DRAFT FINAL

PROJECT SCOPING PLAN FOR PERFORMING A
CERCLA REMEDIAL INVESTIGATION/FEASIBILITY
STUDY (RI/FS) AT THE MUNITIONS WASHOUT FACILITY
AND LEACH FIELD, SENECA ARMY DEPOT ACTIVITY

JULY 1996

**Parsons Engineering Science, Inc.
Prudential Center
Boston, Massachusetts**

**FIGURE 3-7
GROUNDWATER ELEVATION MAP**

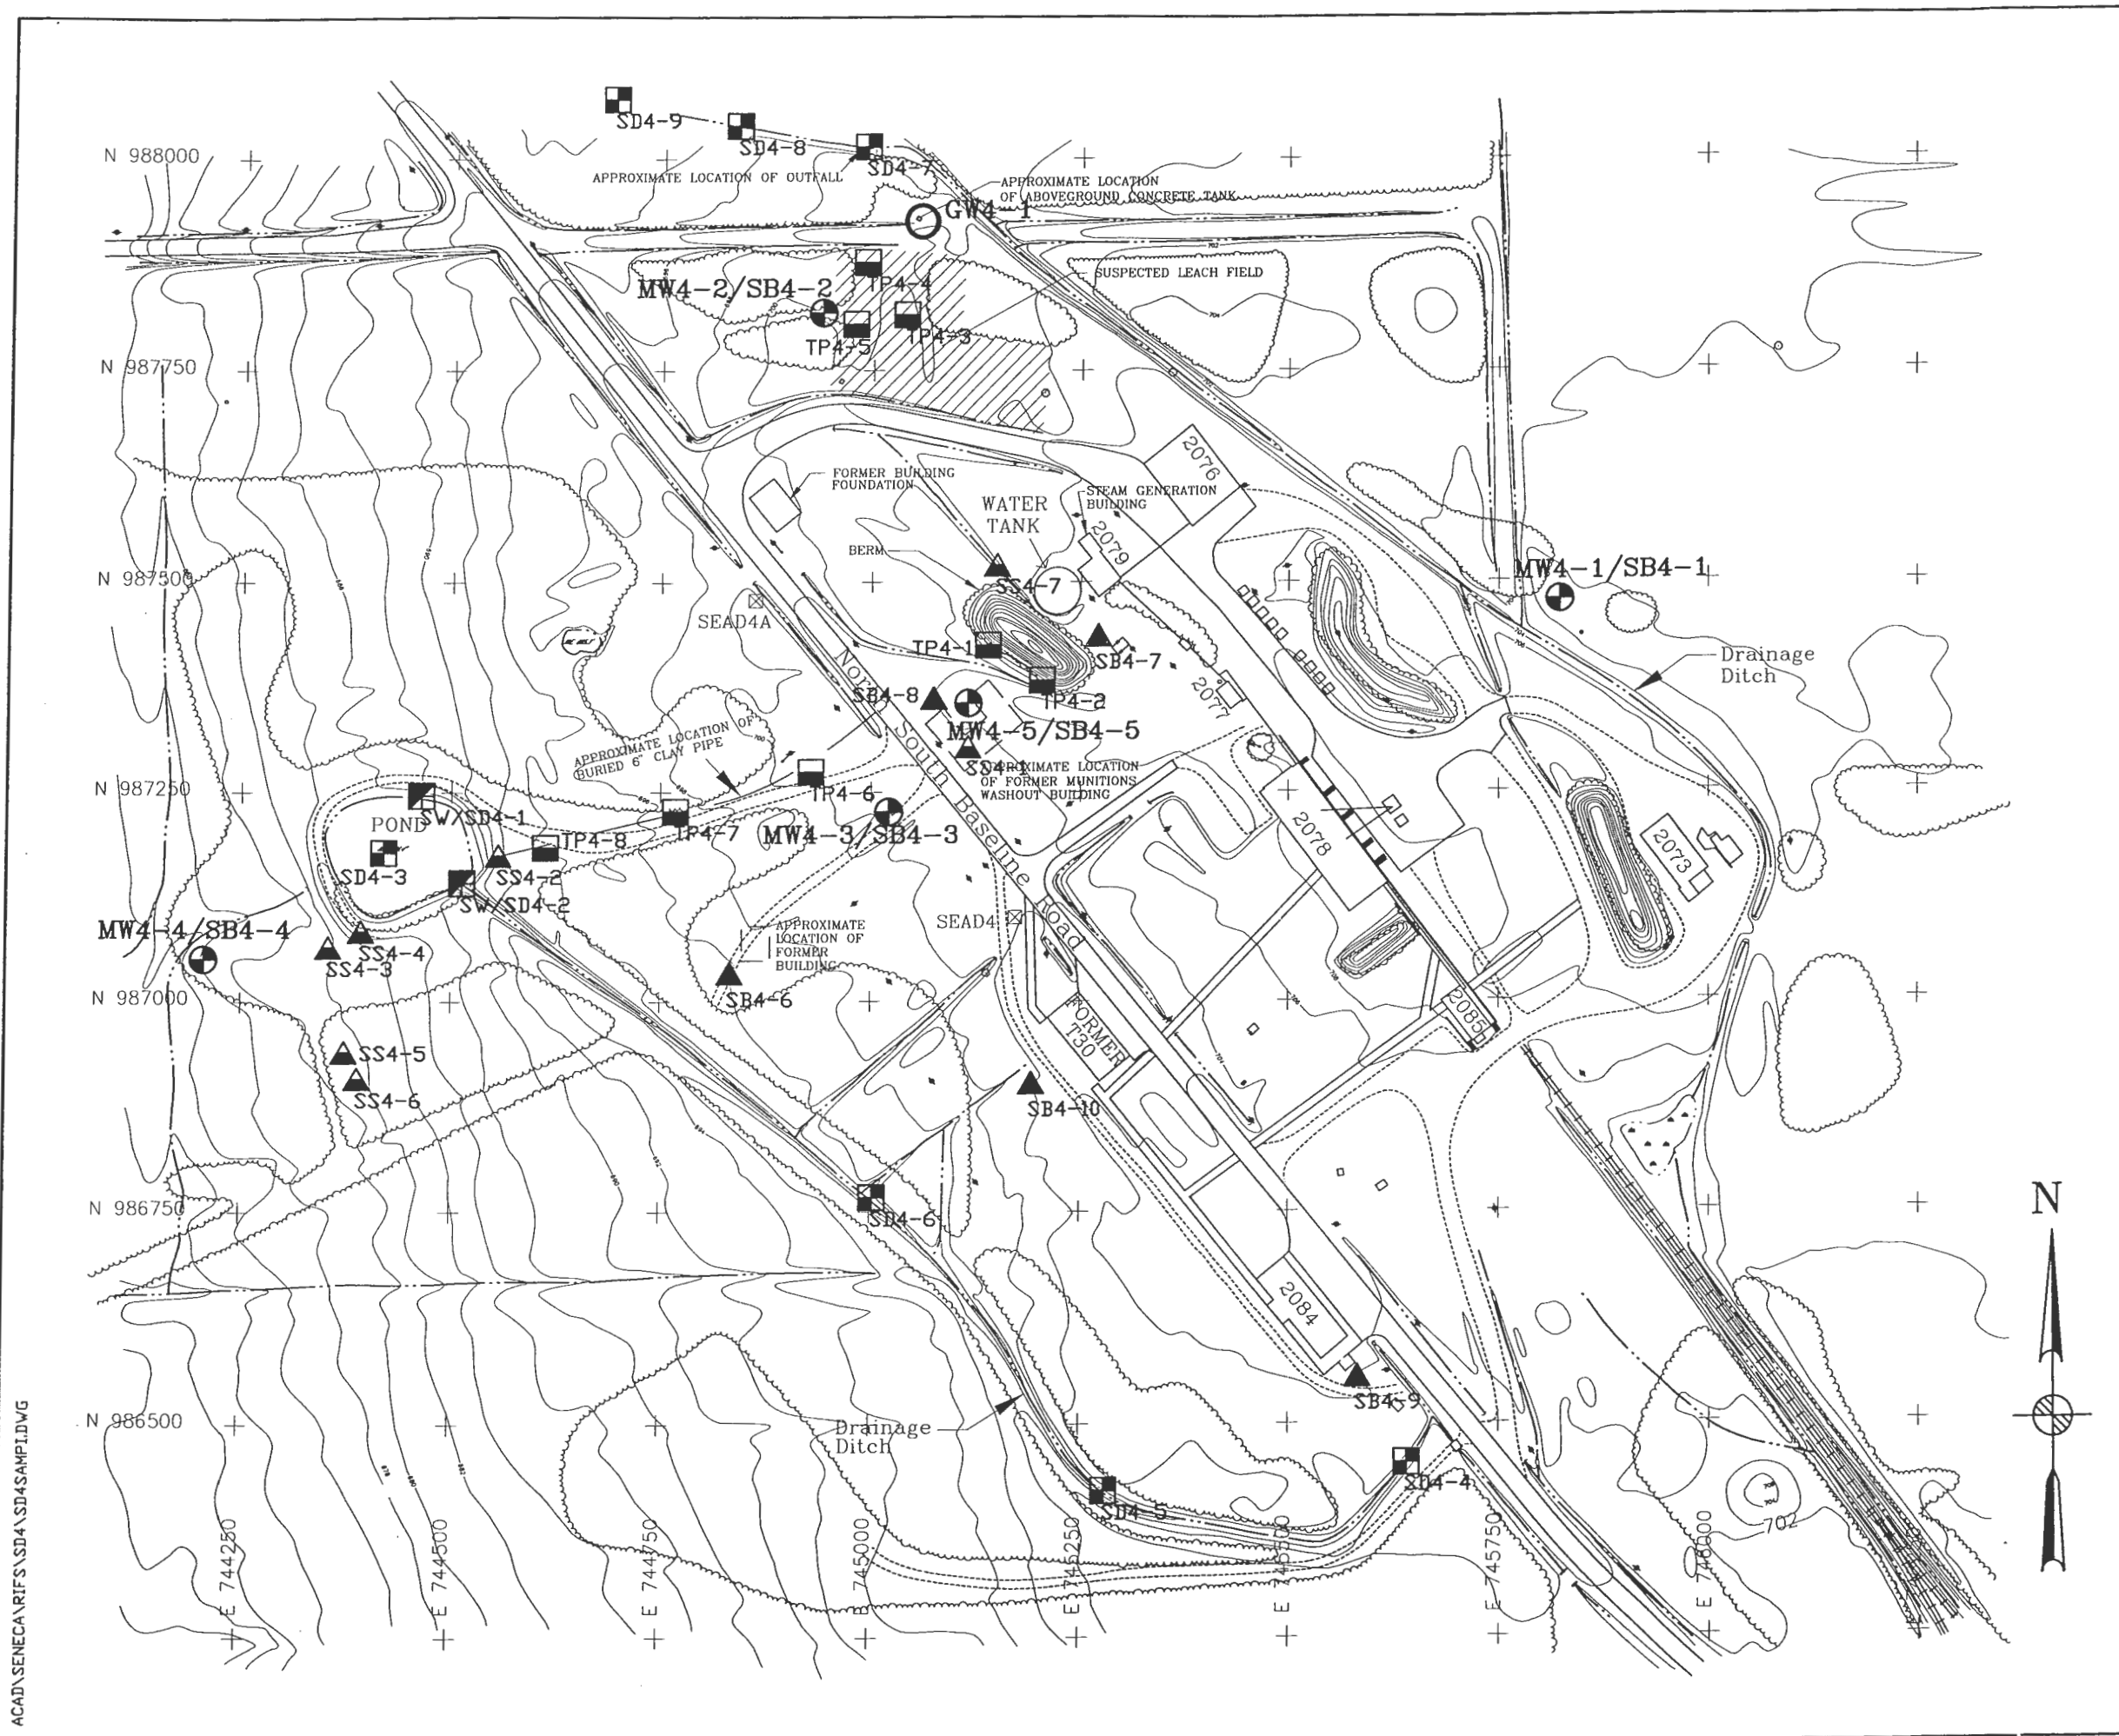
- Comment #3** Figure 3-7: The data presented on this figure have been rounded to the nearest tenth of a foot. However, the data presented in Table 3-1 is shown to the nearest 0.01 feet. The data presented in the figure should be the same as shown in the table and the contouring should be checked.

- Response #3** Agreed. The data presented on Figure 3-7 has been changed to the nearest 0.01 feet, as shown in Table 3-1.
- Comment #4** Figure 3-8: The symbol presented for the surface water/sediment sampling locations is not consistent between the legend and the main body of the figure. The sampling location SB4-1, was not found on the figure.

FIGURE 3-8
SAMPLE LOCATIONS FOR EXPANDED
SITE INSPECTION

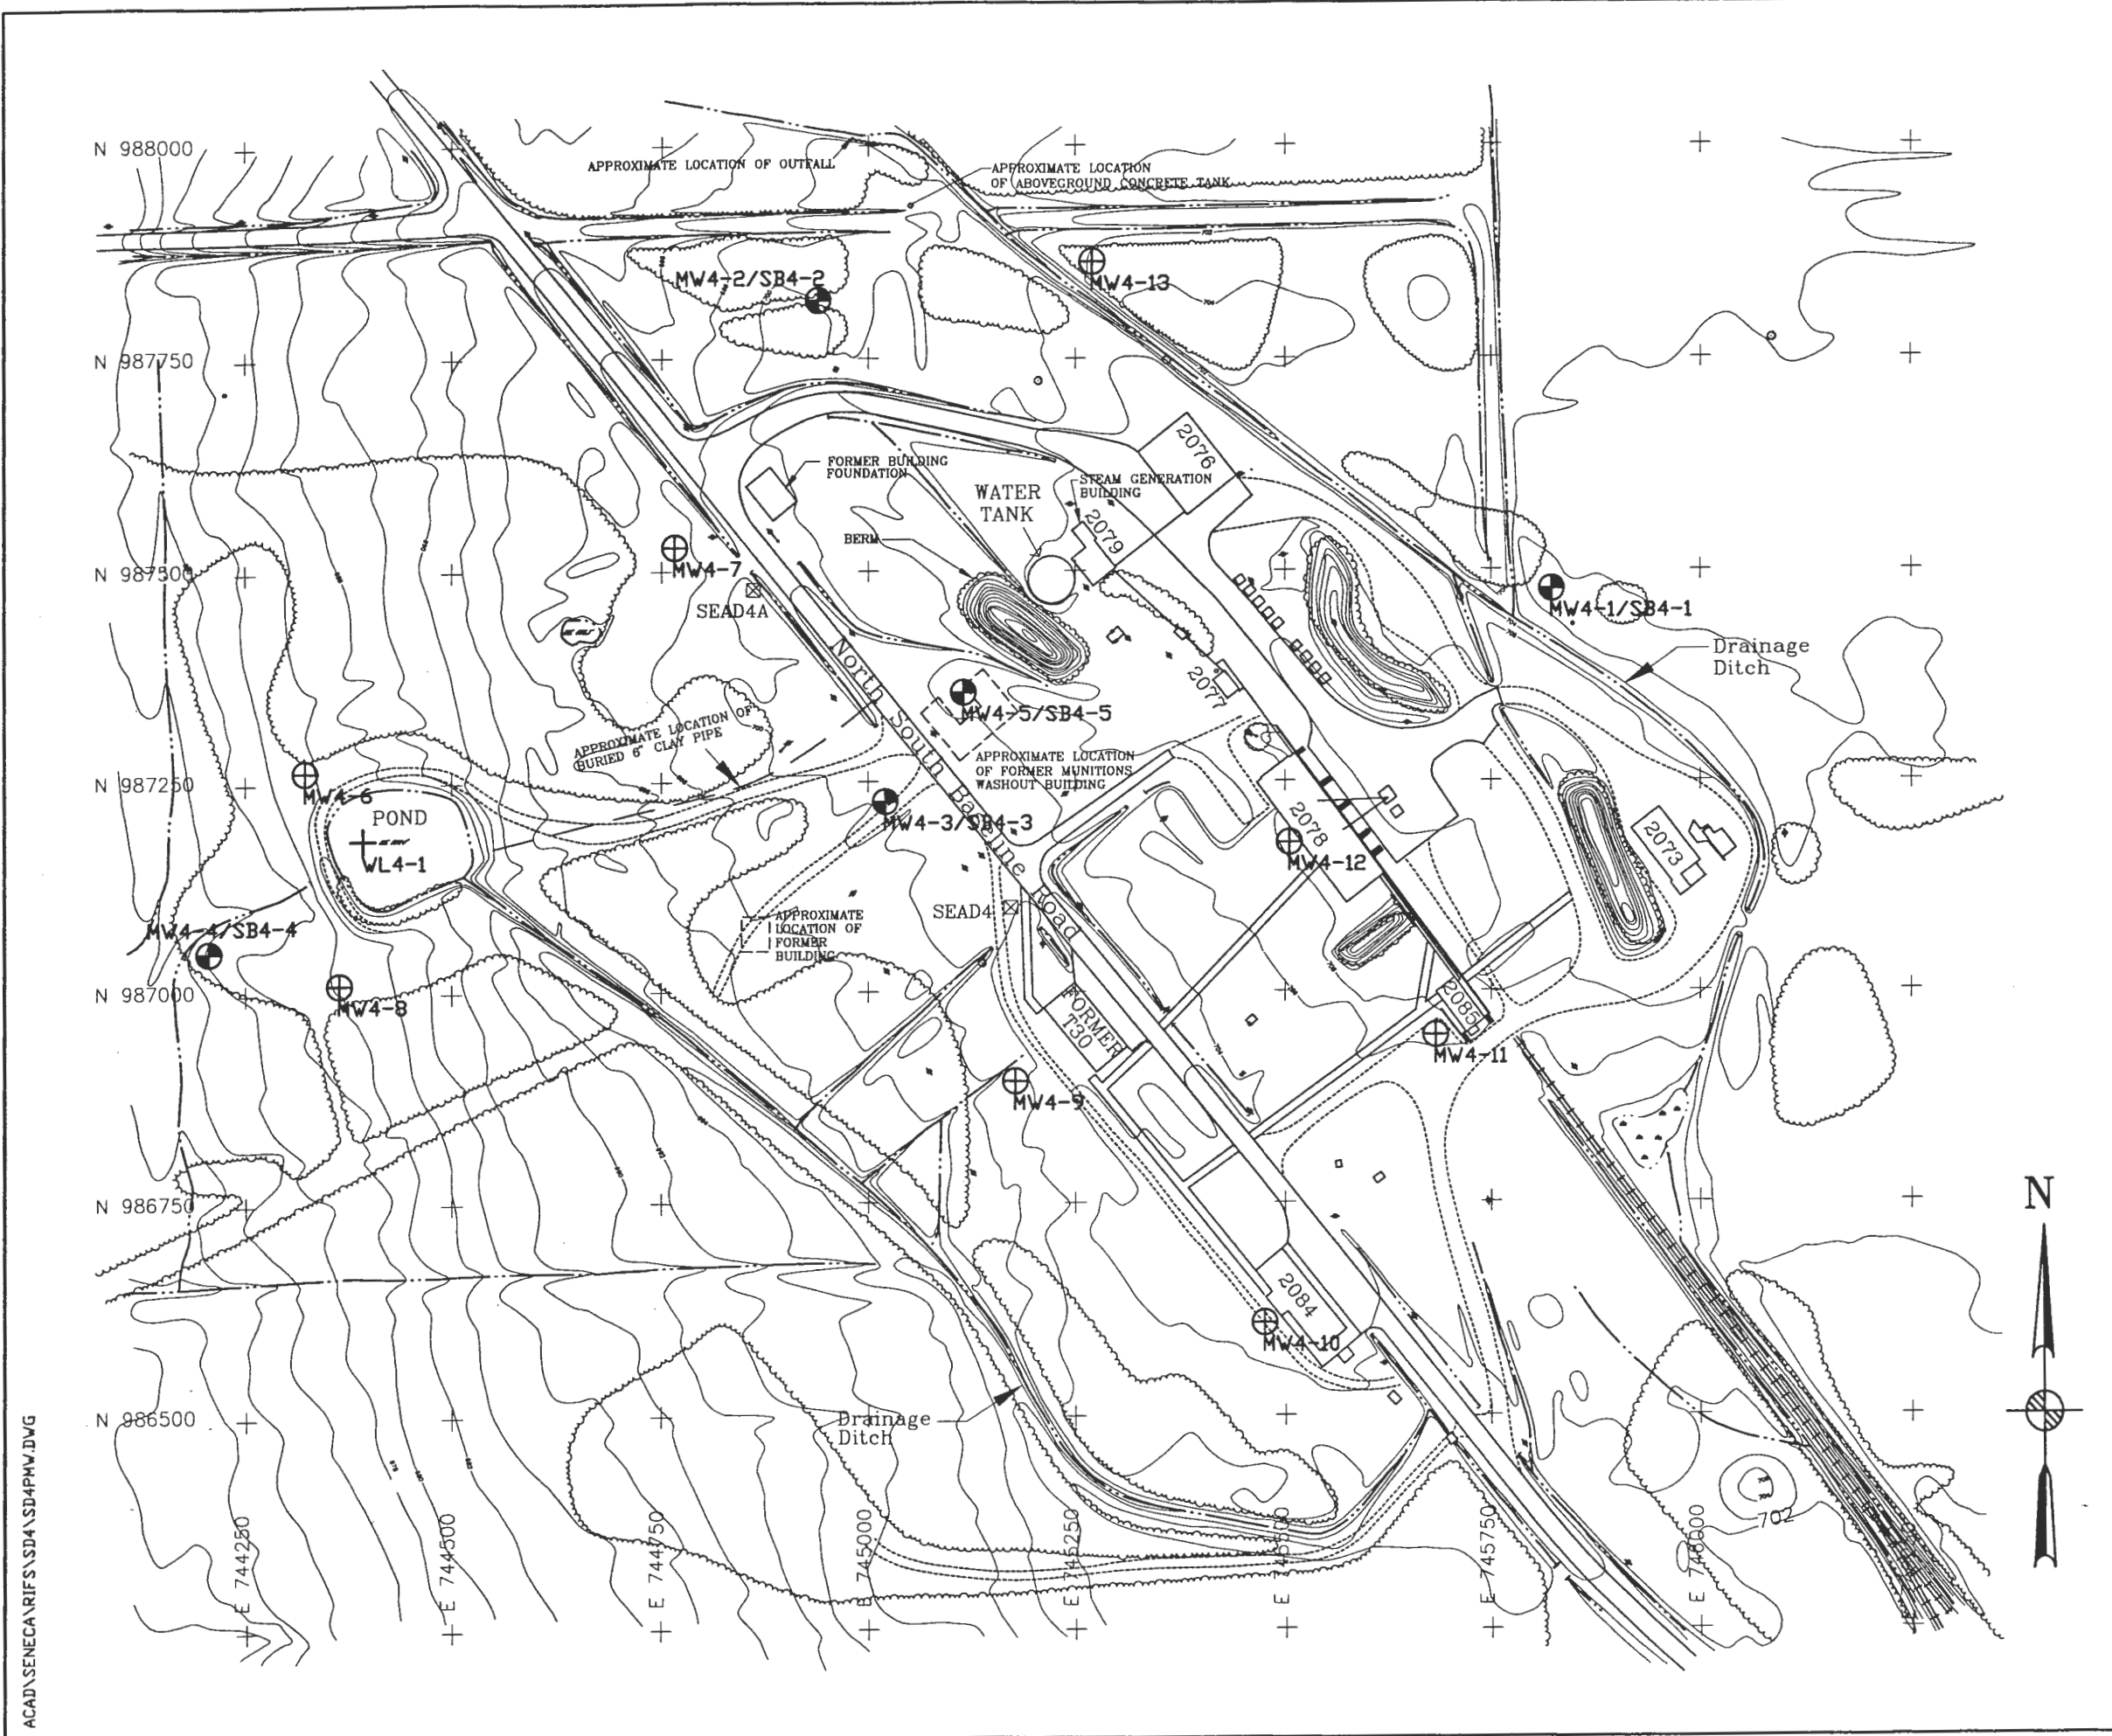
Comment #4 The location of SB4-1, the soil background sample, should be shown in Figure 3-8, "Sample Locations for Expanded Site Inspection."

- Response #4** Agreed. The symbol for the surface water/sediment sampling locations (SW/SD4-1 and SW/SD4-2) was refined so that it is consistent with the symbol used in the legend. Also, the borings SB4-1 through SB4-5 were identified on Figure 3-8; they are associated with wells MW4-1 through MW4-5.

Response #4 Agreed. The location of SB4-1 has been added to Figure 3-8.

FIGURE 4-2
 PROPOSED SURFACE WATER AND
 SEDIMENT SAMPLE LOCATIONS

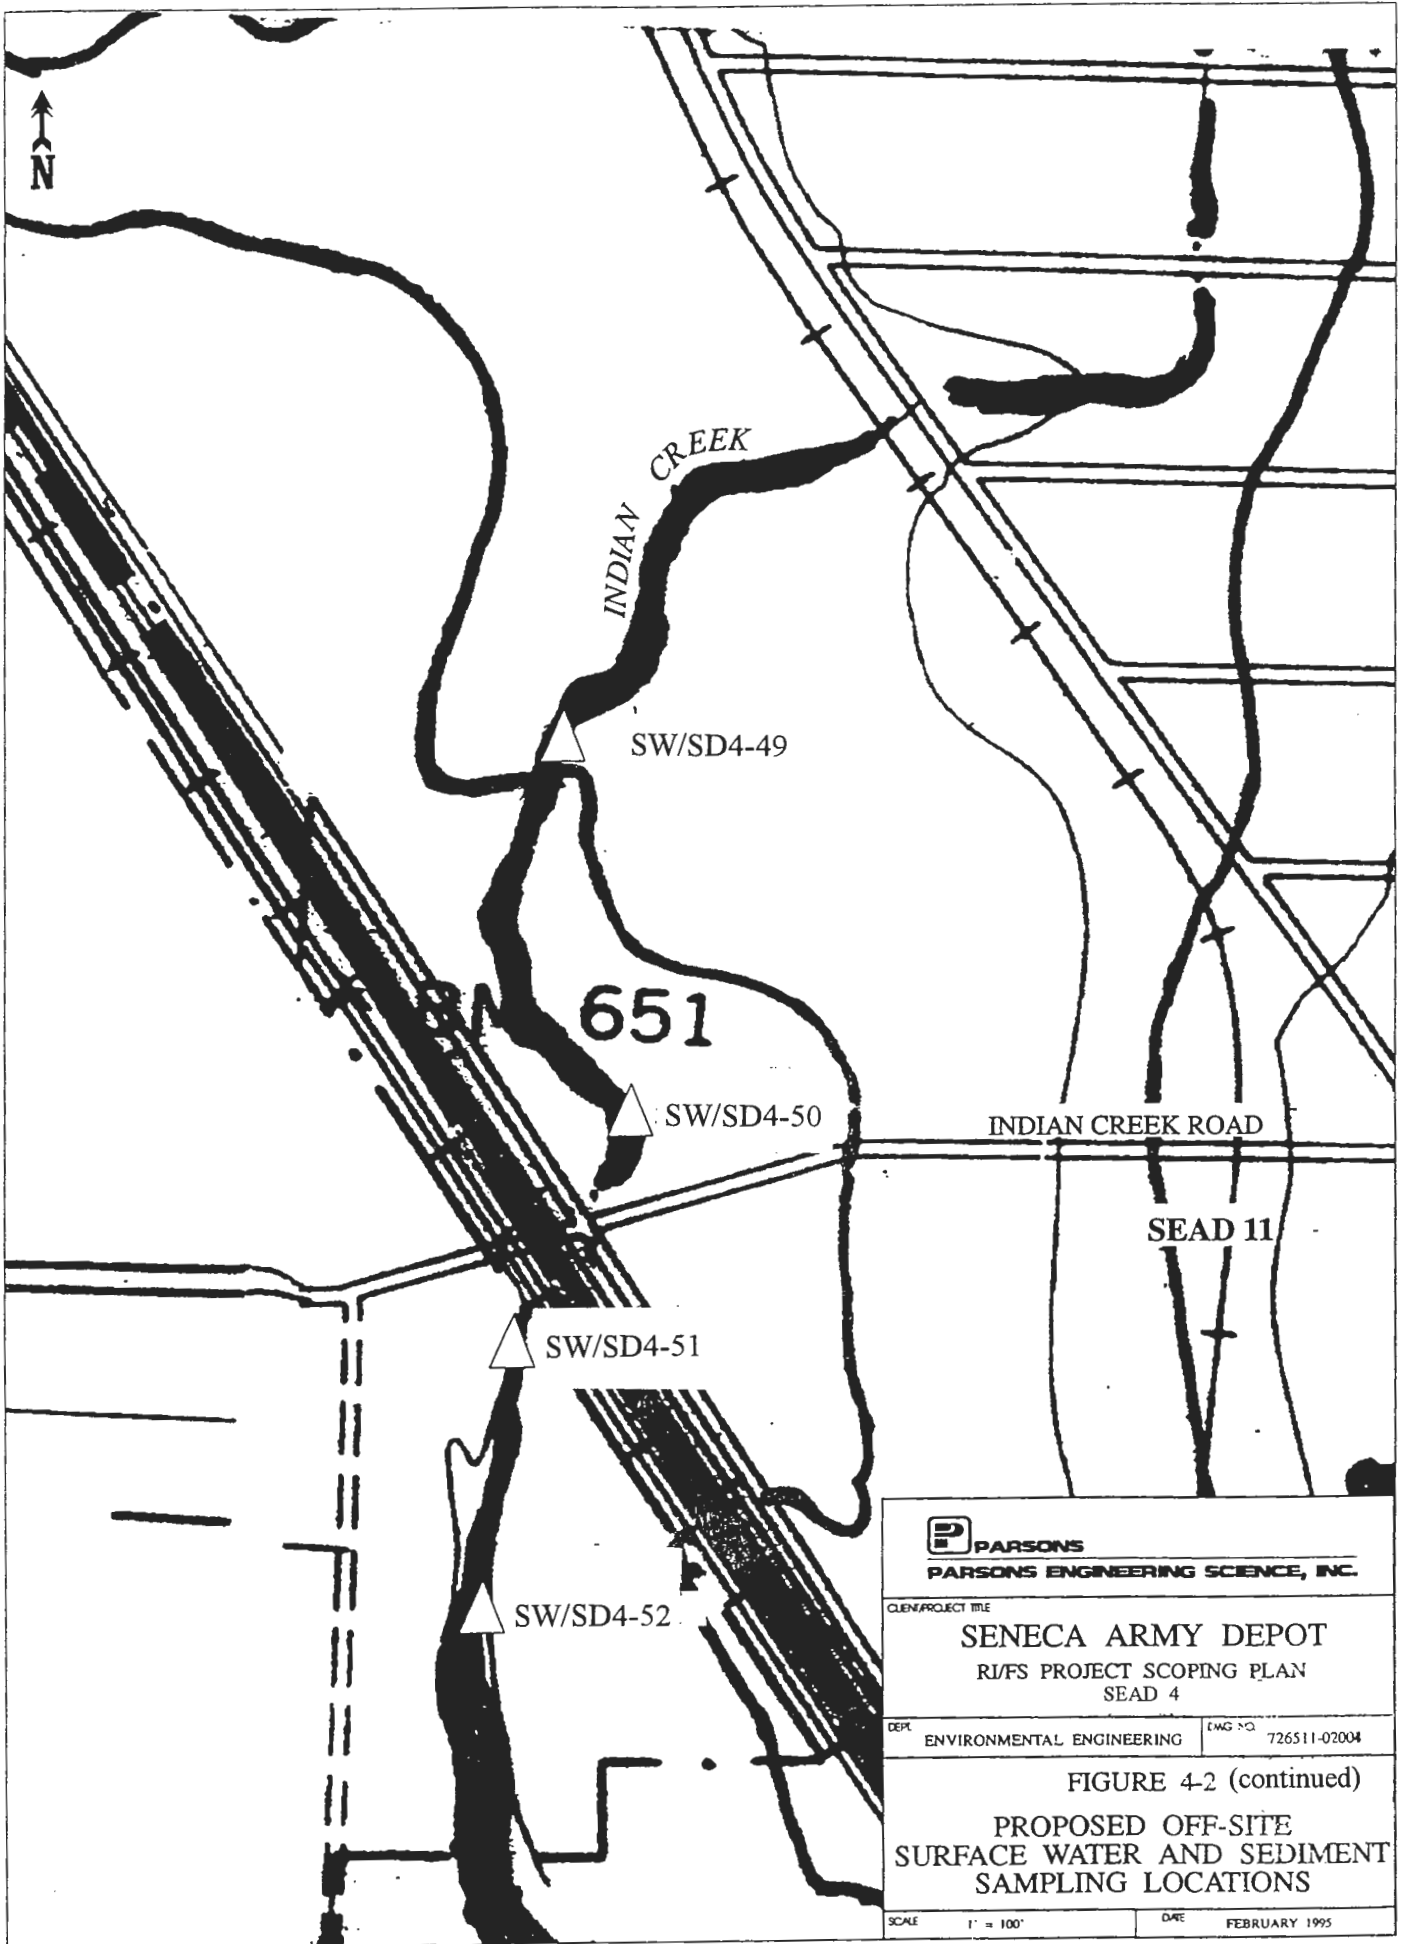
- Response #12** Agreed. The discrepancy on page 4-7 has been corrected.
- Comment #13** Figure 4-2: It appears as if the proposed sediment/surface water sampling location SW/SD4-30 is for all practical purposes the same as the sediment sampling location SD4-5 from the ESI. If this is the case, then there is no reason to recollect a sediment sample. Although the work plan text concludes on page 3-5 that it is unlikely that wastewater was discharged from Building 2084, there is conflicting information on this point. Because of this it may be warranted to collect a sediment sample from the drainage which is located to the northeast of Building 2084.

- Figure 3-6 indicates that surface water flow in the drainage ditch to the northeast of Building 2073 divides approximately 300 feet downgradient from Building 2073. Figure 4-2 concentrates the sediment/surface water

- Comment #1** Figure 4-2 (continued) illustrates the locations of four sampling points, two upstream of Indian Point Road and two downstream from the Road. It is unclear why Indian Point Road was chosen to delineate between upstream and downstream points. The location of SEAD-4 should be provided in this figure, along with the location of the drainage ditch and any discharge points into the Creek. In the future RI/FS Report for SEAD-4, topographic figures indicating surface water drainage should also be provided to illustrate the flow of wastewater and stormwater towards the Creek. Sampling should be conducted in depositional areas.
- Response #1** Agreed. This is because it was reported by former SEDA employees that while the washout facility was in operation approximately 100 gallons of wastewater were discharged to Indian Creek; it was reported to have been

Agreed. Two additional sample locations were added. Additional sample locations have been added to the north-south trending arm of the drainage ditch (SW/SD4-50), and to the northwest-southeast trending drainage ditch that drains from the berm west of Building 2073 (SW/SD4-51). The changes in the SEAD-4 Scoping Plan were made on page 4-8 and Figure 4-2.

SEAD-4 was not included on Figure 4-2 because of scale restrictions. However, to provide a frame of reference for the reader text has been added to page 4-8 of the SEAD-4 Scoping Plan that states that SEAD-4 is located approximately 600 feet east of sample location SW/SD4-51.
